Re: Initial Submission Review: Green Valley Ranch East – Tibet Road Preliminary Plat – Minor Amendment 1
Case Number: 2021-6018-01

On behalf of Oakwood Homes and Terracina Design, we have reviewed the comments dated November, 23 2022. The following is a response to comments.

N. TIBET ROAD - TRIBUTARY T TO 48TH AVENUE INFRASTRUCTURE SITE PLAN

NOTES & TYPICAL SECTIONS

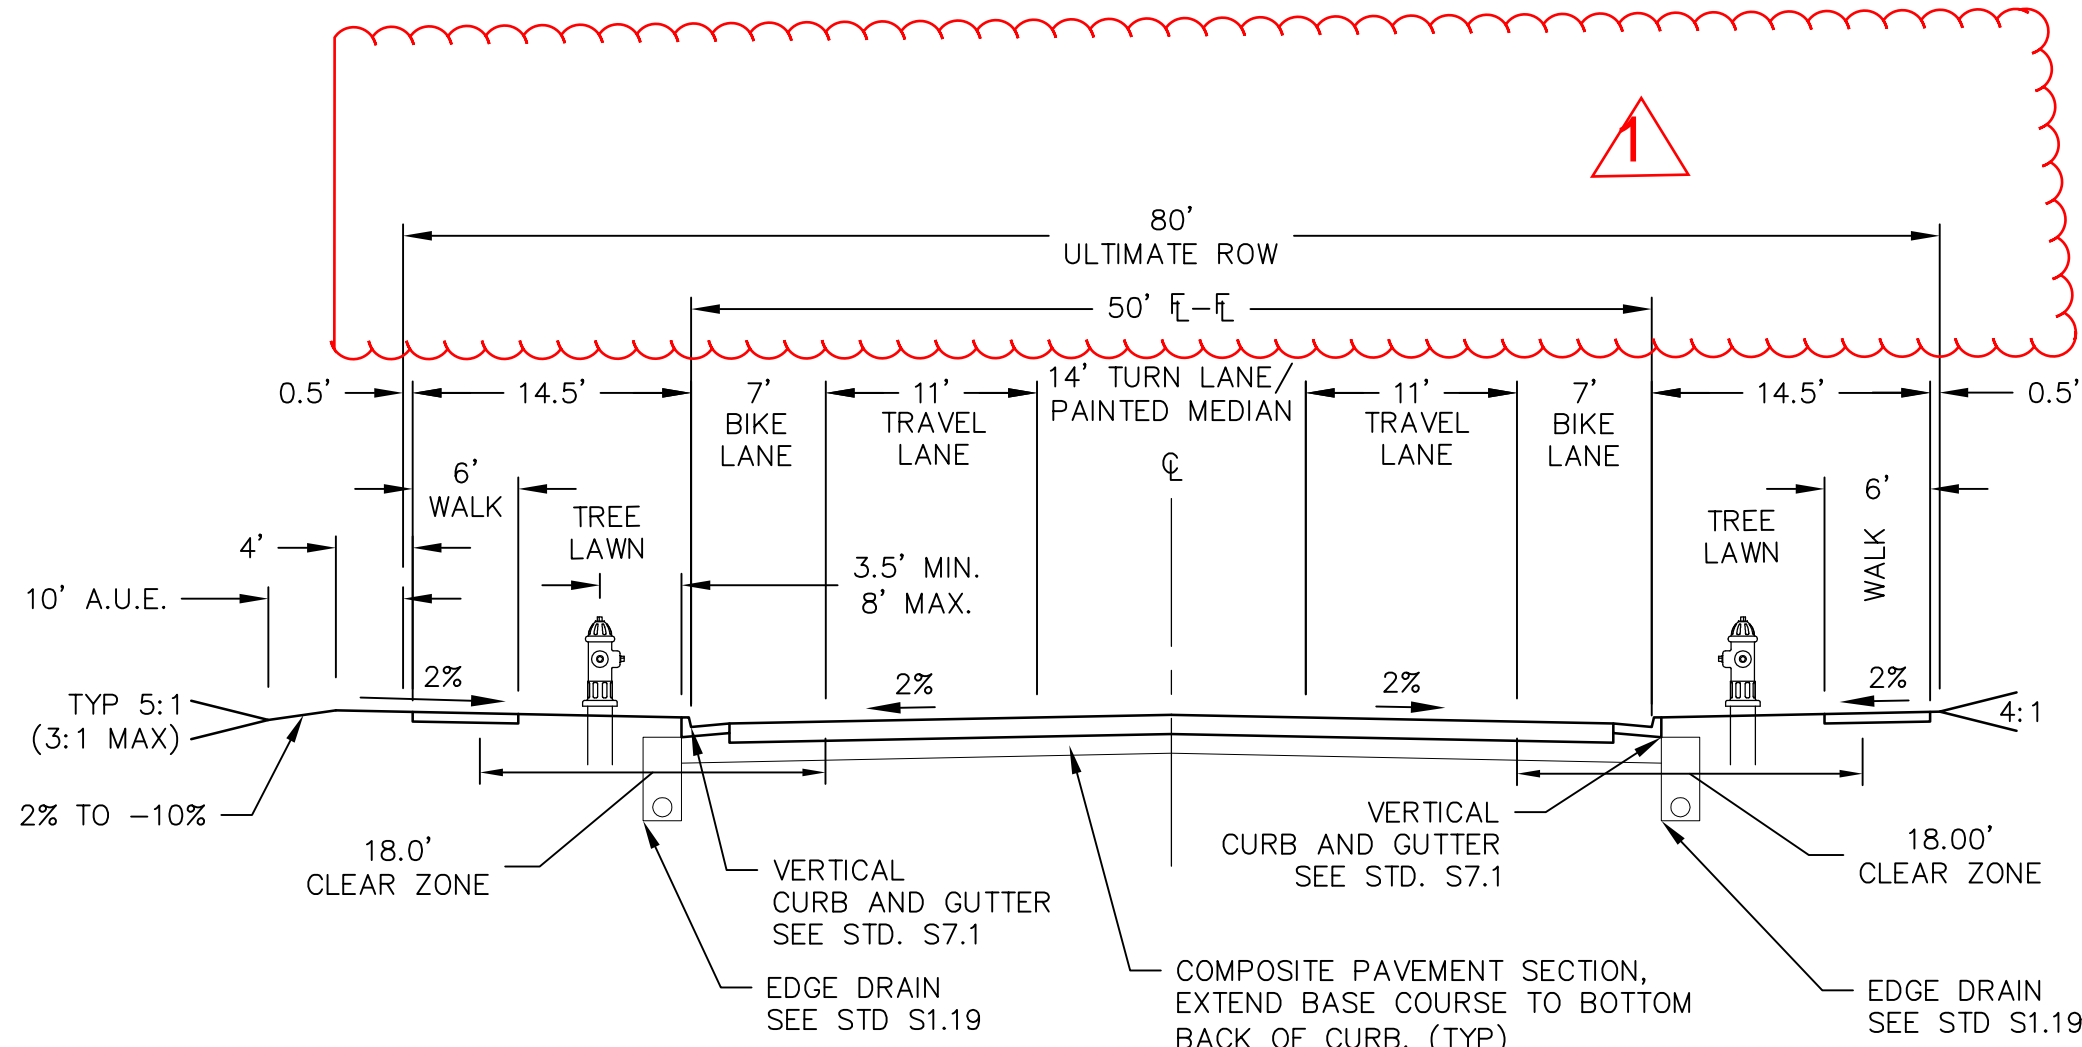
Add the following note:

Prior to final acceptance of public improvements, if the adjacent site is not under construction, the curb cut/curb returns and cross pan must be removed and replaced with sidewalk, landscaping and curb and gutter at the developer's expense. The developer acknowledges the risk of constructing the curb cut without approved civil plans for the adjacent site showing the curb cut.

DEWBERRY RESPONSE: THE FOLLOWING NOTE HAS BEEN ADDED.

SITE PLAN

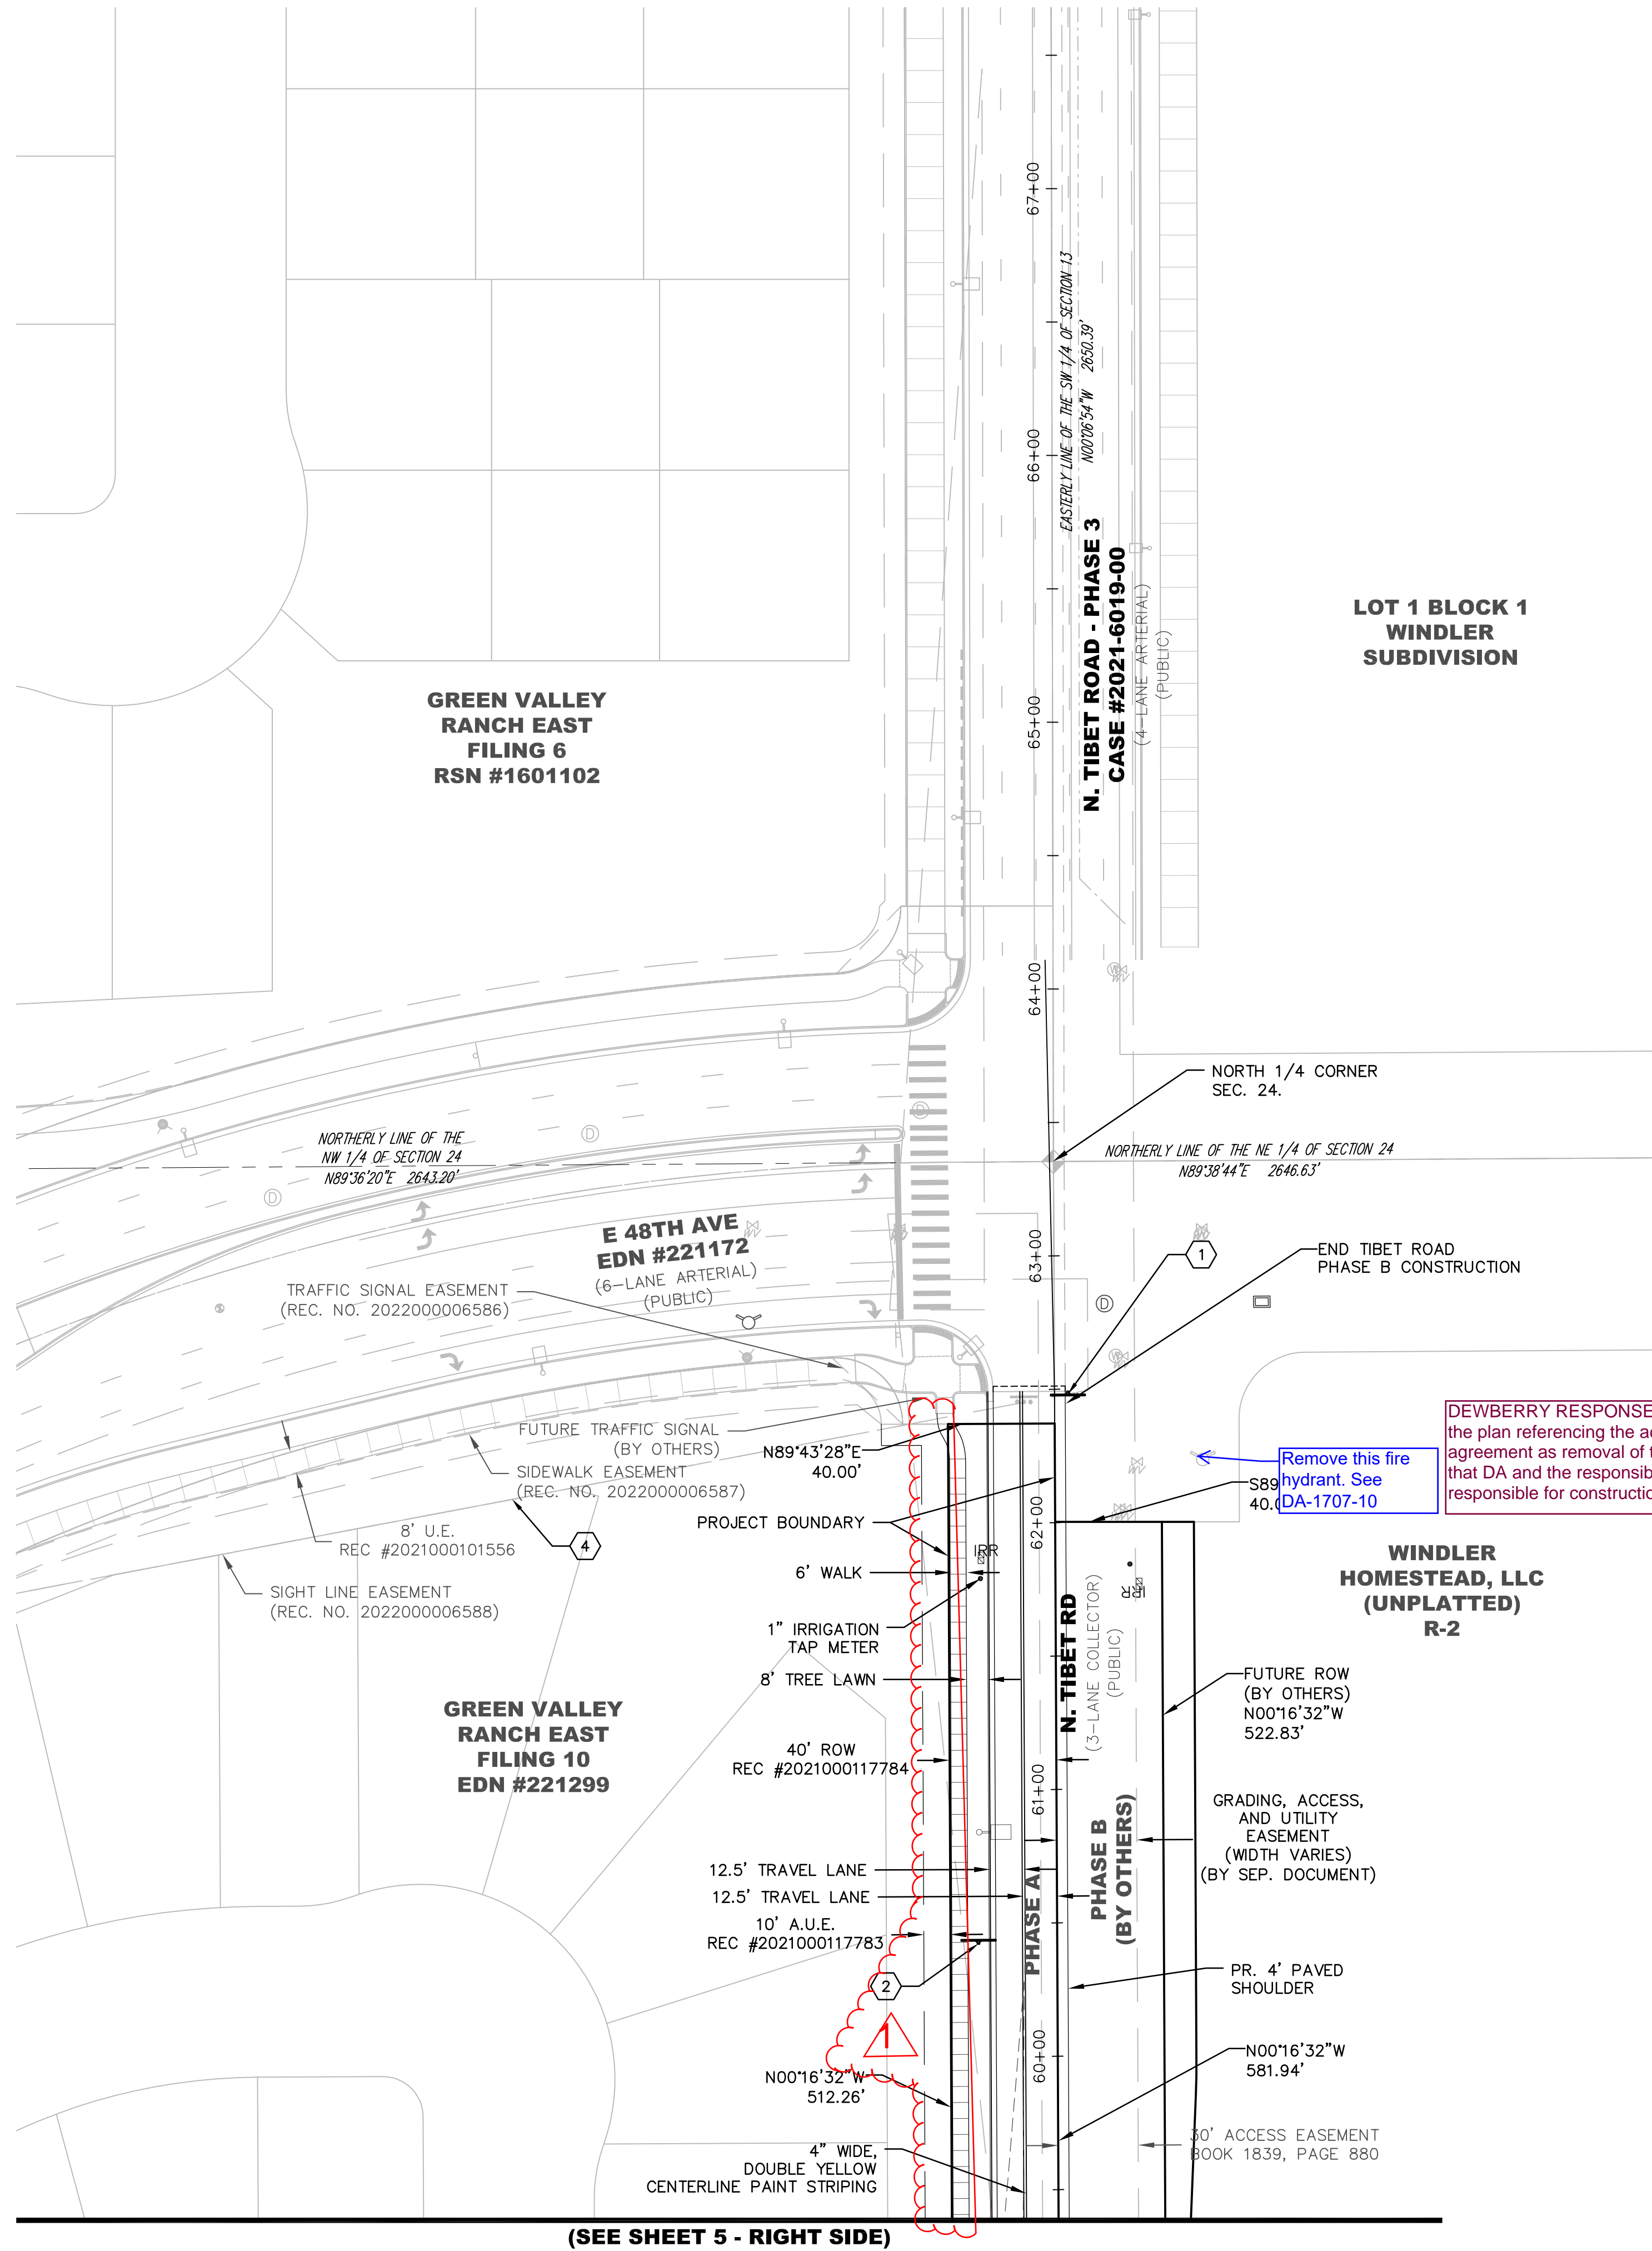
Remove this fire
hydrant. See
DA-1707-10

DEWBERRY RESPONSE: labels have been added to
the plan referencing the adjacent development
agreement as removal of this hydrant is applicable to
that DA and the responsibility of the developer
responsible for construction of that Site Plan.

CURBSIDE LANDSCAPE REQUIREMENTS

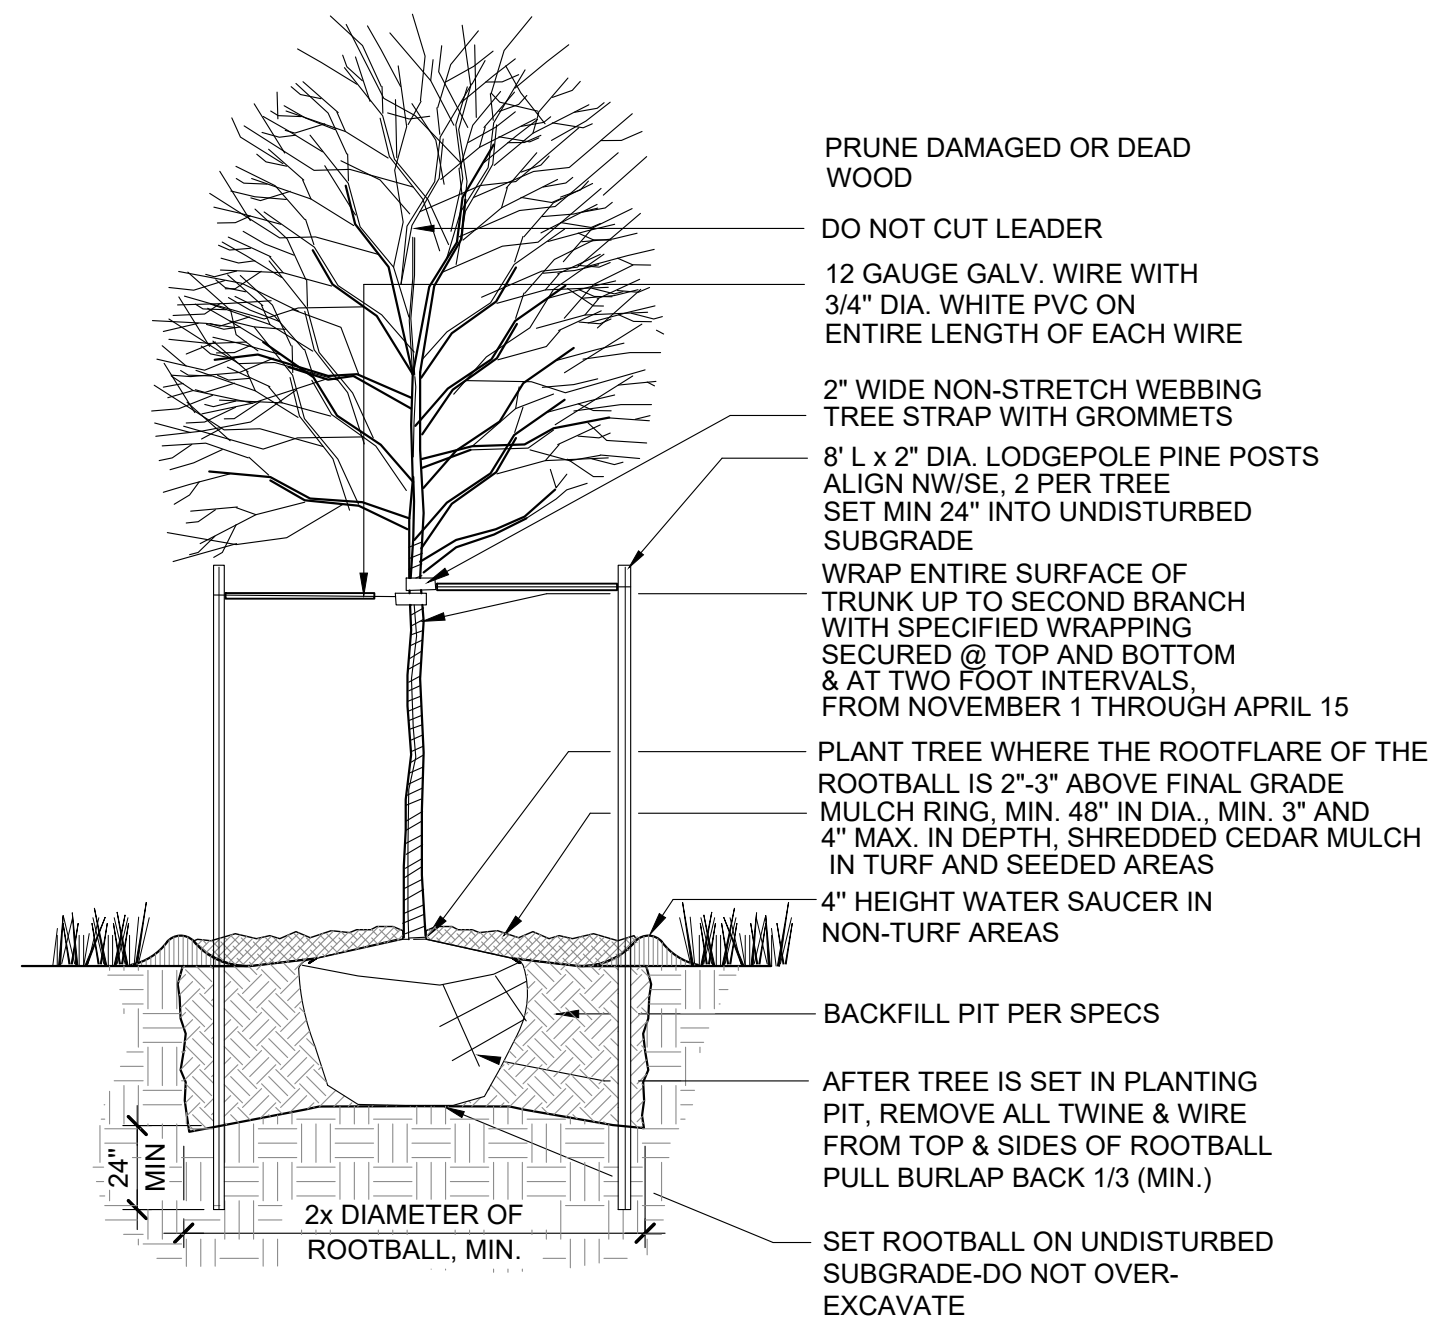
i can't find any info on this variety. Please provide some details, including max height

Max height and spread are 18"-24". See LVWN.com for reference.
